Access Compliance Report

Public Rights-of-Way

(Pedestrian Signals)

Intersection ID: N/A	Main Street:	Cross Street: N/A	Location: N/A
ADA ID: FB5462672EFF	Signal Type: One Push Button-Non APS	Overall Compliance: No	Severity Score: BTN 1: N/A BTN 2: N/A No BTN: N/A
Codes/Mitigation Info/Possible Solution		Field Measurements/Component Compliance

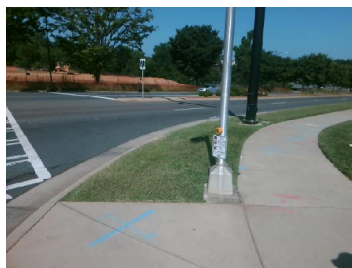
Surveyor Notes: TEXT HT 1/2

PROW/ADA: R410.6, TMUTCD 4e.08, R406.2

Possible Solutions: Replace Signal Push Button With APS Button on New Post. Remove & Replace Sign.
